TULSA METROPOLITAN AREA PLANNING COMMISSION

For Meeting No. 2515

May 28, 2008

PUD-579-A/PUD-519-B: Detail Site Plan – Northerly 466.12' of Lot 4 and Lot 5 – Tallgrass Office Park; Cancer Treatment Center of America; 10109 East 79th Street South; TRS – 8407; CZM 54; Atlas 1413; PD 18 CD 8; CO/PUD.

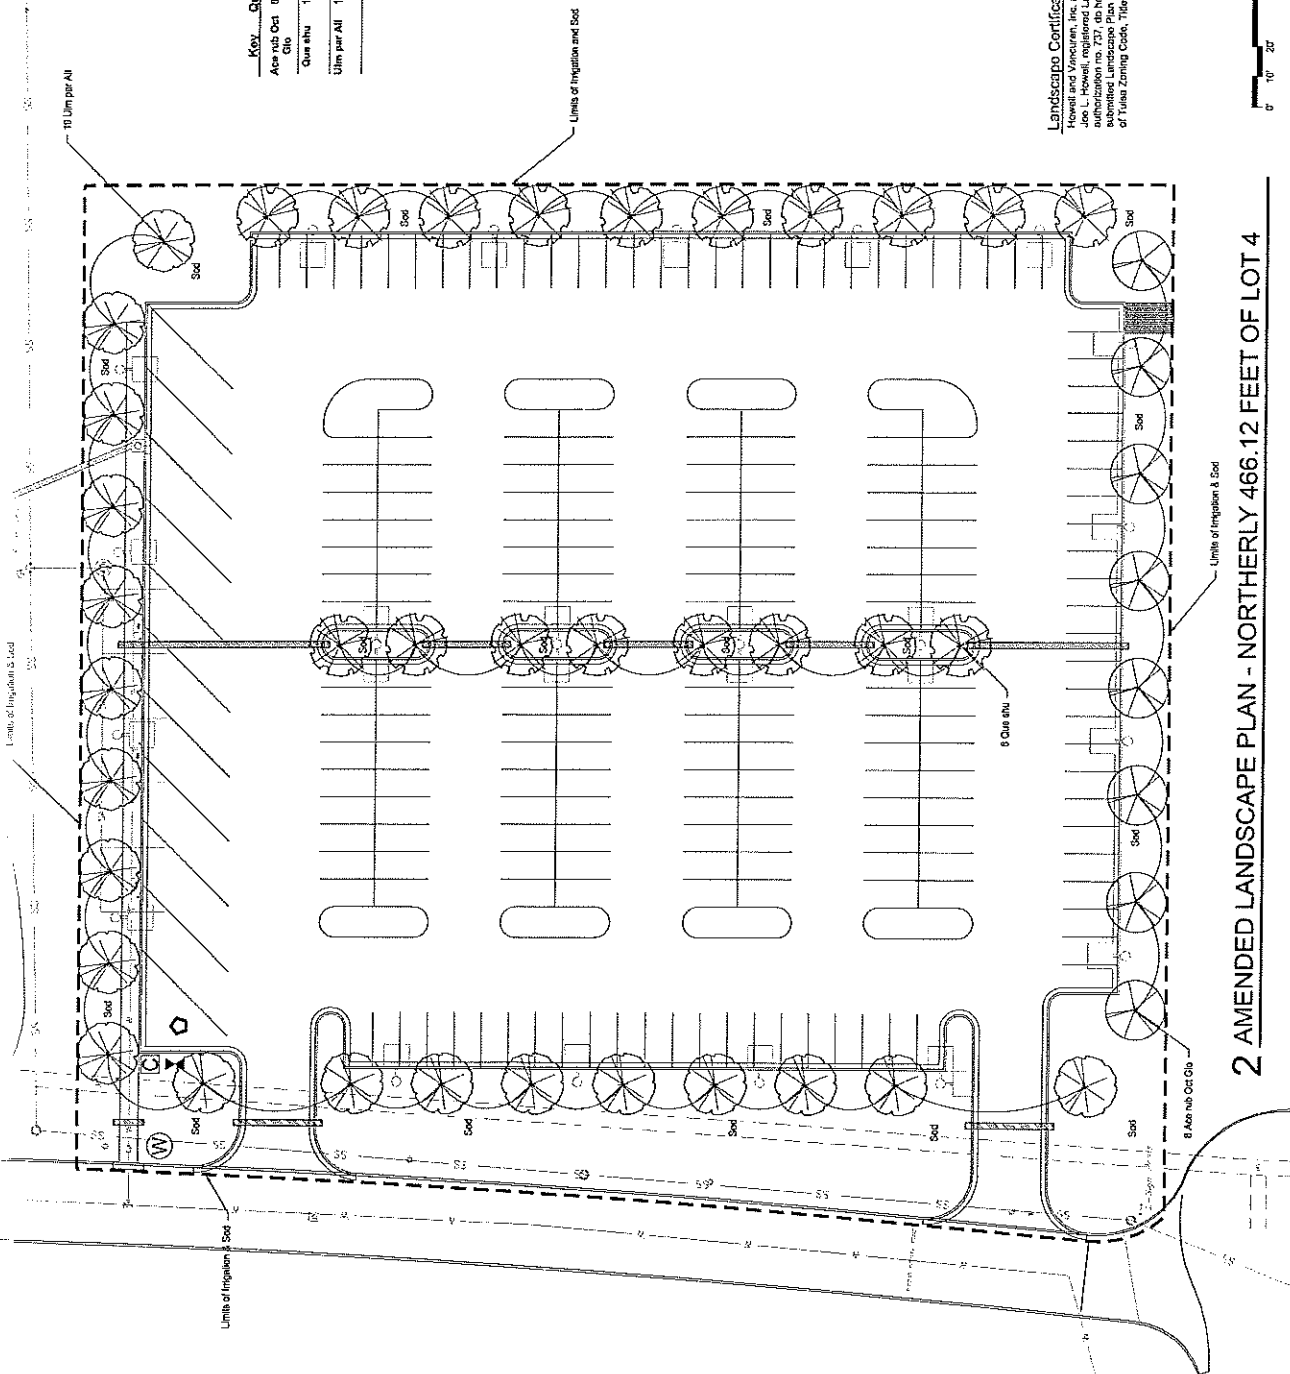
The applicant is requesting approval of a detail site plan for a 52,871 square foot expansion of the Cancer Treatment Center. The expansion will include a four (4) story - 48,615 square foot (SF) outpatient accommodation, a new 1,708 sf staff dining room, a 947 SF storage addition and a 1,601 sf addition to the mechanical room.

With the expansion, the Cancer Treatment Center is within the maximum permitted building floor area and land coverage limits. The submitted site plan also meets applicable building height and setback limitations. Additional parking has been provided per the Zoning Code. Landscaping is being provided per the landscape chapter of the Zoning Code and adopted PUD development standards, and all sight lighting will be limited to 25-feet in height and will be directed down and away from adjoining properties per application of the Kennebunkport Formula.

Staff recommends **APPROVAL** of the detail site plan for the expansion of the Cancer Treatment Center, Northerly 466.12' of Lot 4, and Lot 5 – Tallgrass Office Park.

PUD 595-B / CORRIDOR SITE PLAN
DETAIL SITE PLAN LAND AREA SUMMARY
& DEVELOPMENT STANDARDS
DAVE & BUJSTERS, LOTS 7 & 8, BLOCK 1, HOME CENTER
AMENDED
(DEVELOPMENT AREA "D" - INCLUDES LOTS 5, 6, 7, & 8,
BLOCK 1, HOME CENTER AMENDED)

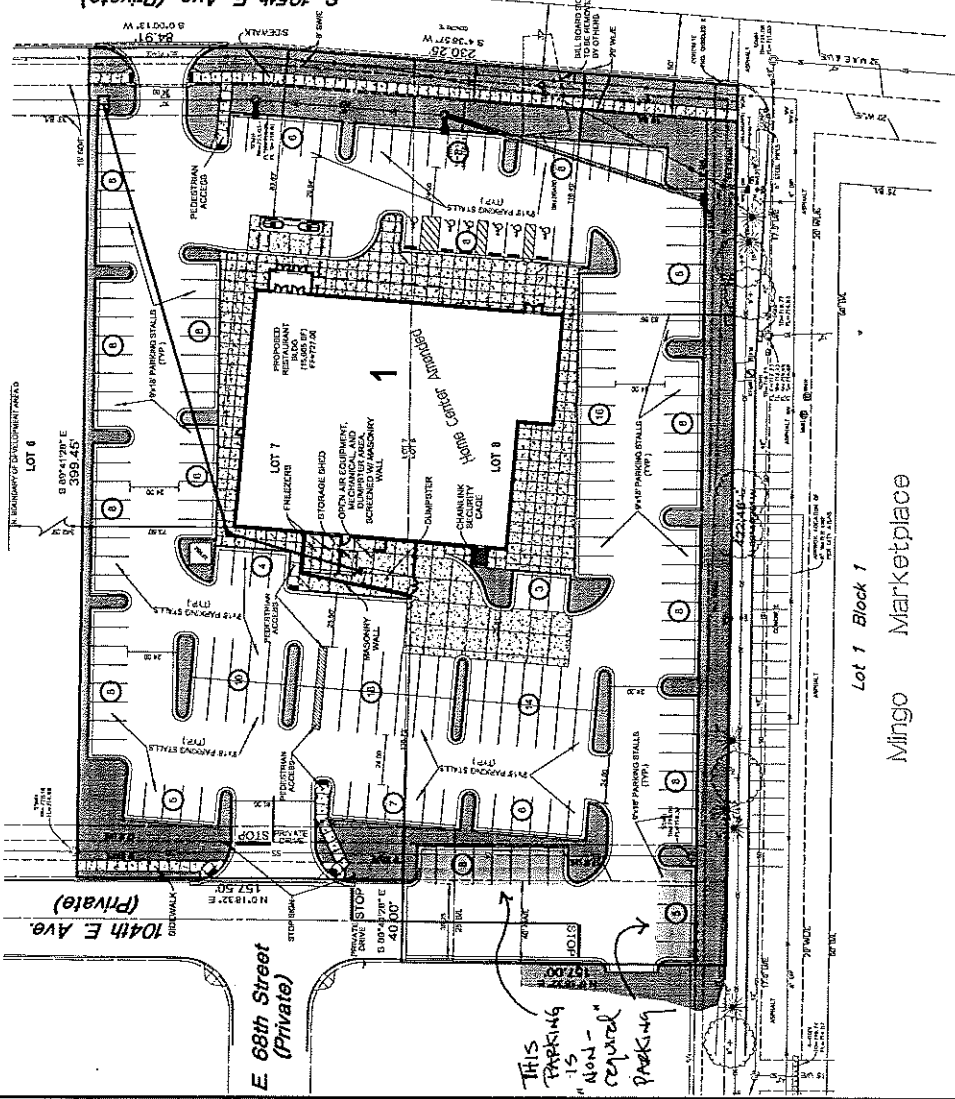
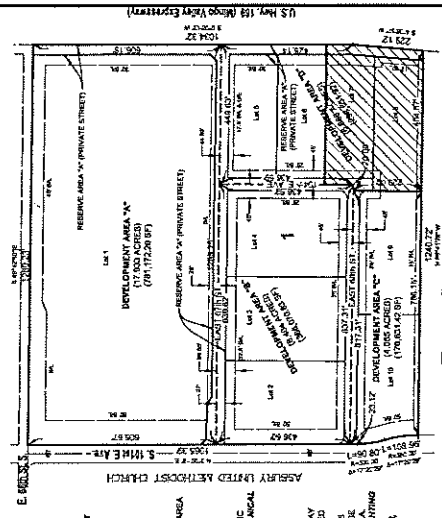
The applicant is requesting approval of a detail site plan for construction of a 15,665 square foot (sf) restaurant on Lots 7 and 8, Block 1 – Home Center Amended. The proposed Use Unit, Use Unit 12 – Eating Establishments, Other than Drive-ins is a permitted use within PUD-595-B.

The submitted site plan meets all applicable building floor area, lot coverage, building height and setback limitations. Parking has been provided per the Zoning Code, and a 6' screening fence will be constructed around all mechanical equipment and trash containers per PUD development standards. Landscaping and open space is provided per the landscape chapter of the Zoning Code and adopted PUD development standards. All sight lighting will be limited to 25-feet in height and will be directed down and away from adjoining properties per application of the Kennebunkport Formula. Sidewalks are provided along 104th East Avenue and 105th East Avenue per subdivision and PUD regulations. Pedestrian circulation is provided from both of the private streets.

The applicant has applied for a lot combination (Application LC-99) for Lots 7 and 8. Concurrently, PUD minor amendment application #PUD-595-B-2 has been filed to reflect the aforementioned lot combination. Both the lot combination and minor amendment will be heard by the TMAPC on June 18th.

Therefore, staff recommends **APPROVAL** of the detail site plan for Dave & Buster's, Lots 7 & 8, Block 1 – Home Center Amended, Development Area D of PUD-595-B. Approval of this site plan is contingent upon receipt of the approval of applications LC-99 and PUD-595-B-2.

**Z-7024-SP-1**

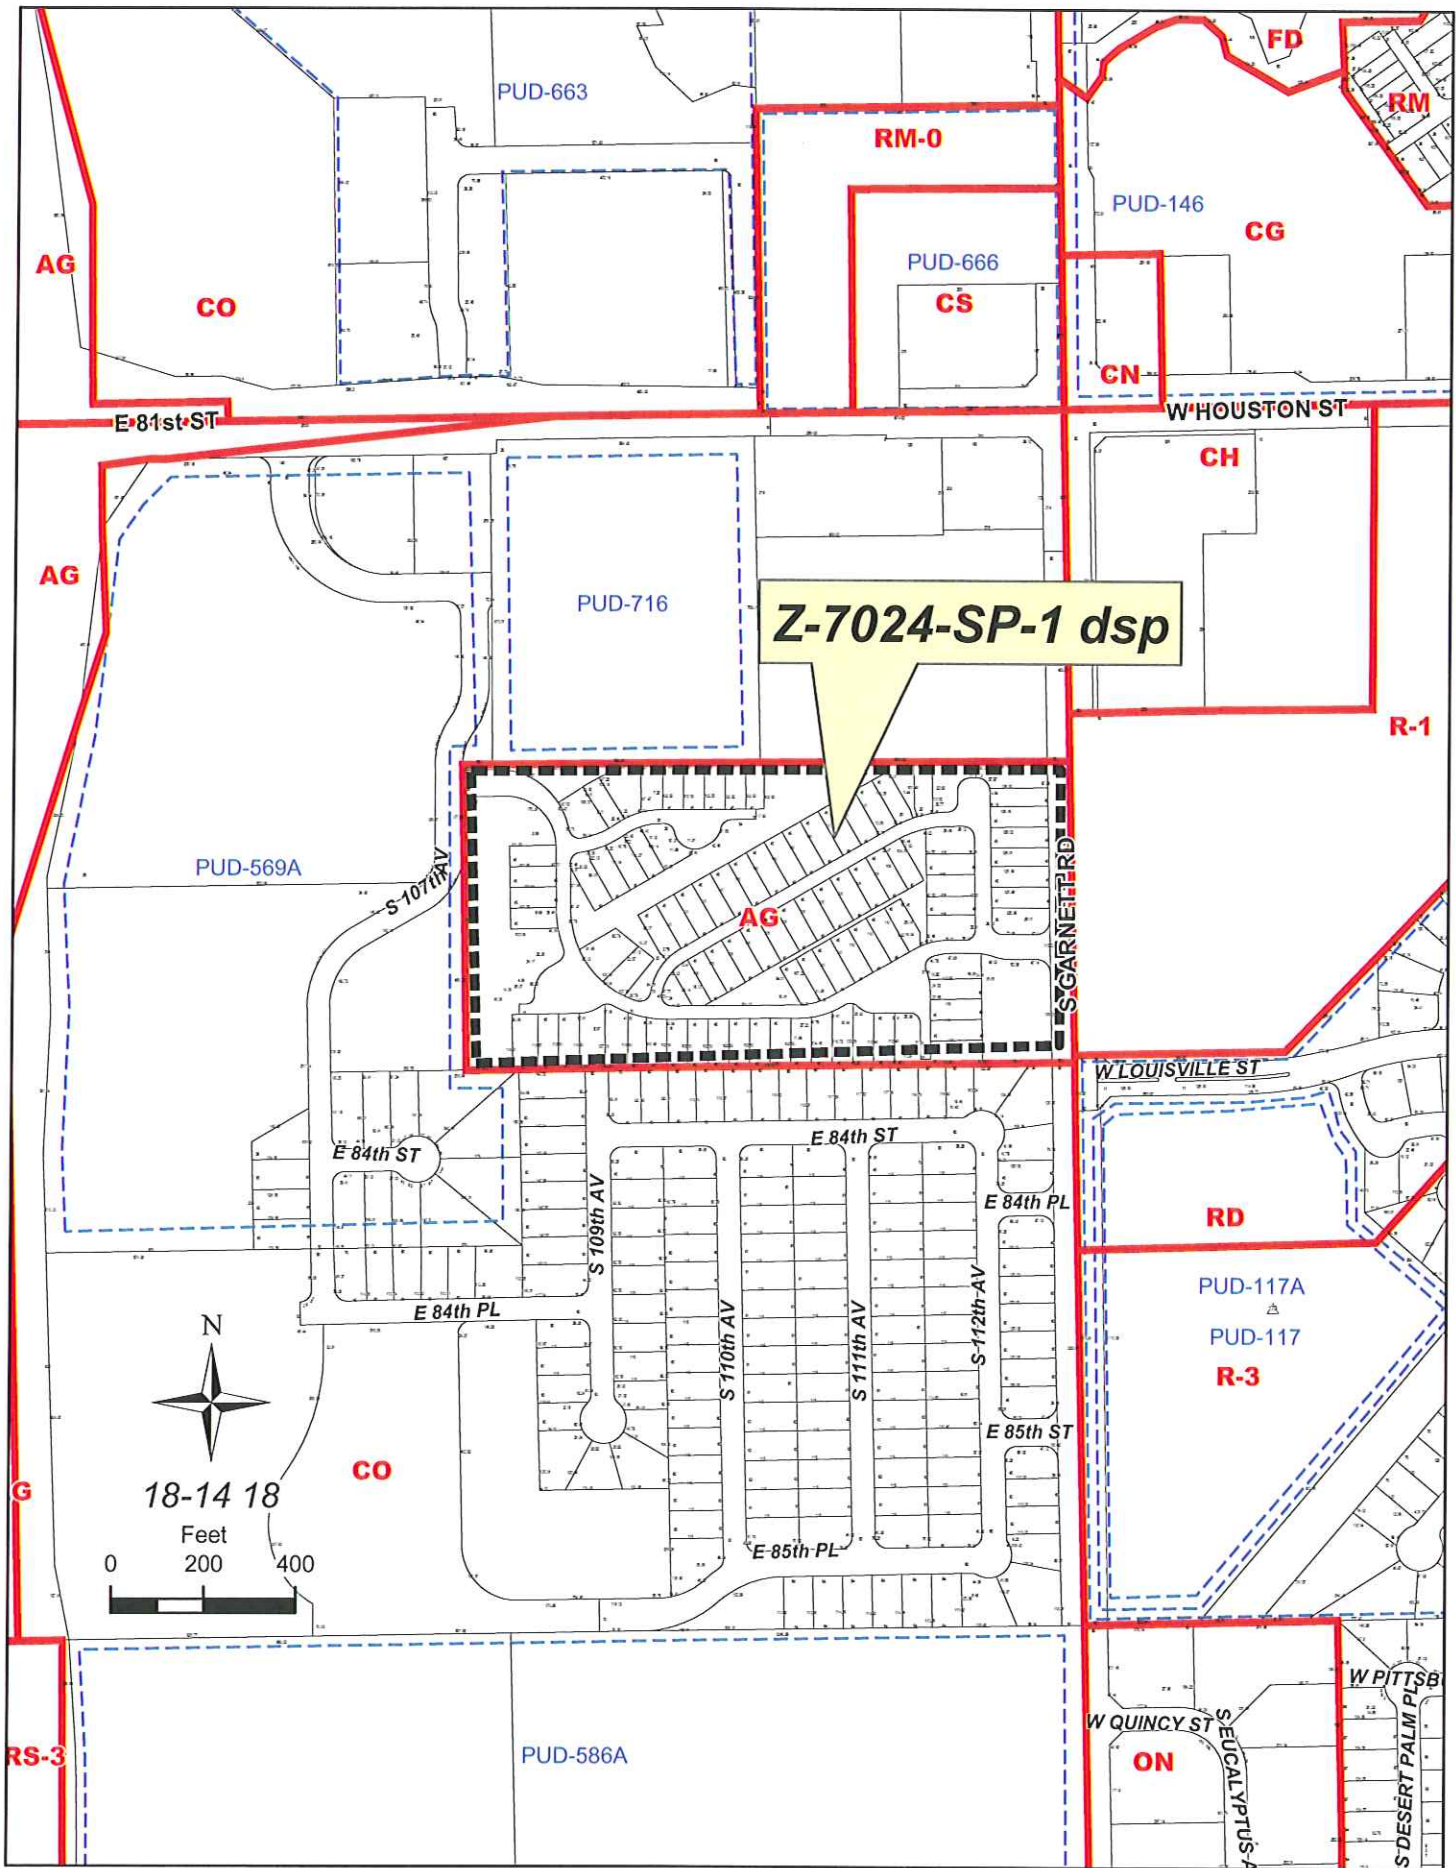
The applicant is requesting approval of a detail site plan for Ridgecrest Subdivision, Corridor Site Plan #Z-7024-SP-1. The proposed use, Use Unit 8 – Multifamily Dwellings, and Similar Uses are permissible uses within this Corridor District.

The approval of corridor plan Z-7024-SP-1, in concept included the review of the required land area per dwelling unit and bulk and area requirements of the subdivision as a whole. This over-all detail site plan review was a requirement of the original concept plan approval. As is the case with most residential Corridor and PUD development within the City of Tulsa, the Bulk and Area requirements on a lot-by-lot basis will be reviewed and enforced in the building permit process by the City of Tulsa Zoning Official. Detail Site Plan review by the TMAPC will still be required for development in reserve or common areas.

Staff recommends **APPROVAL** of the overall detail plan for Ridge Crest Subdivision, Corridor Plan #Z-7024-SP-1.

## Waterford Plaza Phase II 91st and South Sheridan Tulsa, Oklahoma Architectural Site Plan May 13, 2008

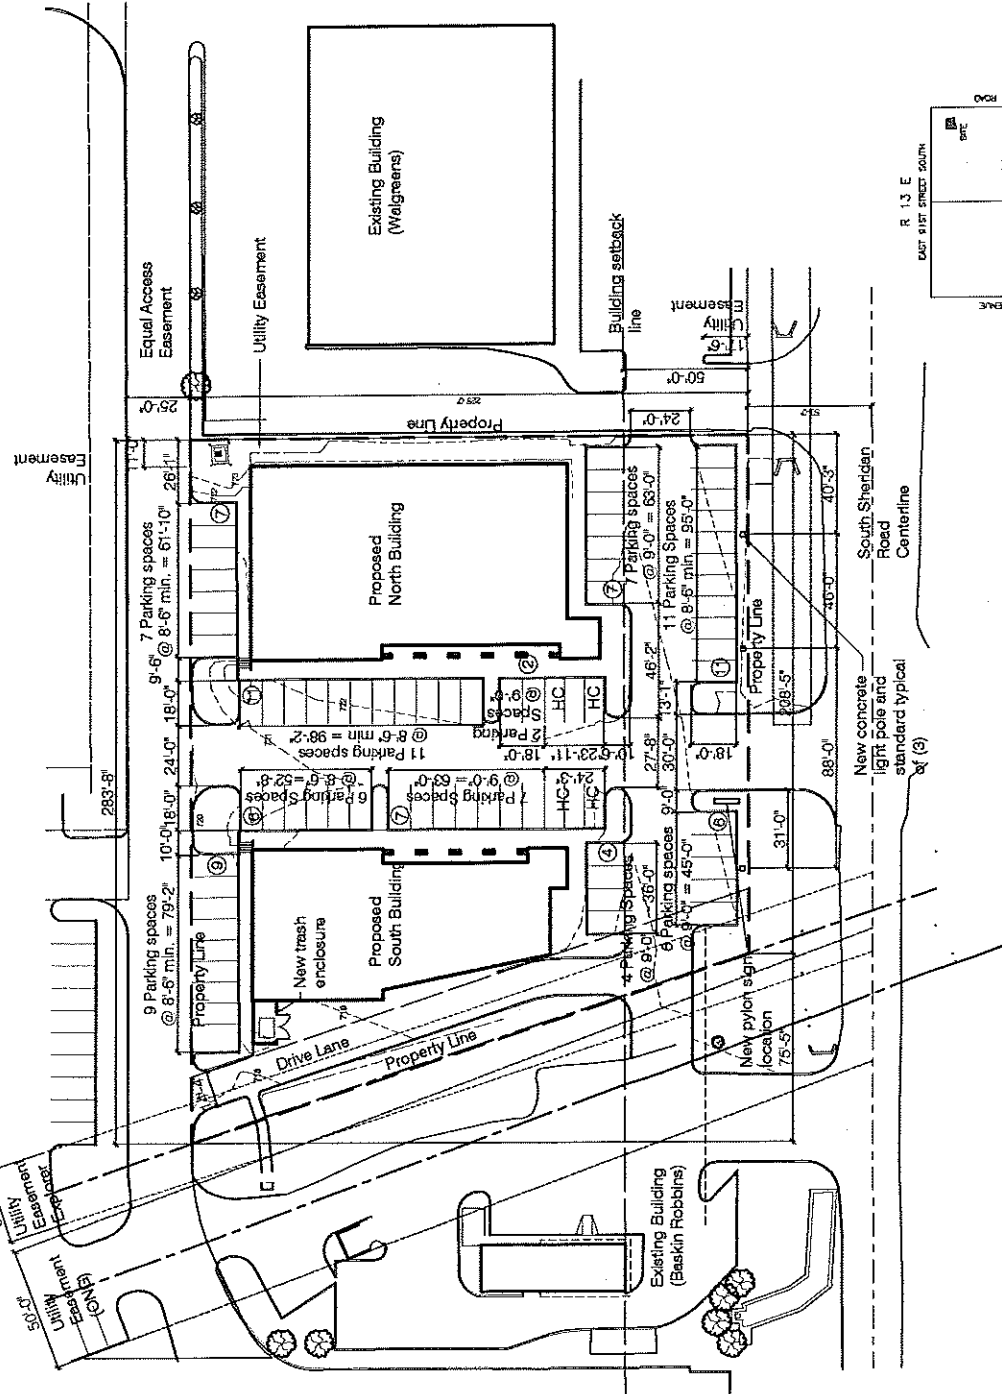
The applicant is requesting approval of a detail site plan for one 9,858 square foot (sf) and one 6,342 sf mixed use commercial buildings. The proposed uses, Use Units 11, 12, 13 and 14 are permitted uses within PUD-206.

The proposed 16,200 sf of floor area is within the 20,750 sf permitted by the PUD. Submitted plans meet all other applicable building height and setback limitations. Parking has been provided per the Zoning Code and all sight lighting will be limited to 12-feet in height and will be directed down and away from adjoining properties per application of the Kennebunkport Formula.

Sidewalks are being required along Sheridan Drive. A pedestrian circulation plan requirement was not included in the approval of this PUD. Also, the applicant has informed INCOG that Sheridan Drive is scheduled for widening in the near future. There are no other sidewalks along Sheridan Drive to the immediate north and south of the subject tract. Therefore, staff recommends approval of a fee in lieu of the sidewalk requirement so a sidewalk may be installed at the time Sheridan Road is widened for capacity purposes.

Staff therefore recommends **APPROVAL** of the detail site plan for Lot 1, Block 1 – "Parcel 1" of Boatman's Bank; Development Area A – PUD-206 with the following conditions:

A fee in lieu of the sidewalk requirement is paid to the City of Tulsa so a sidewalk may be installed along Sheridan Road at the time the street is widened.
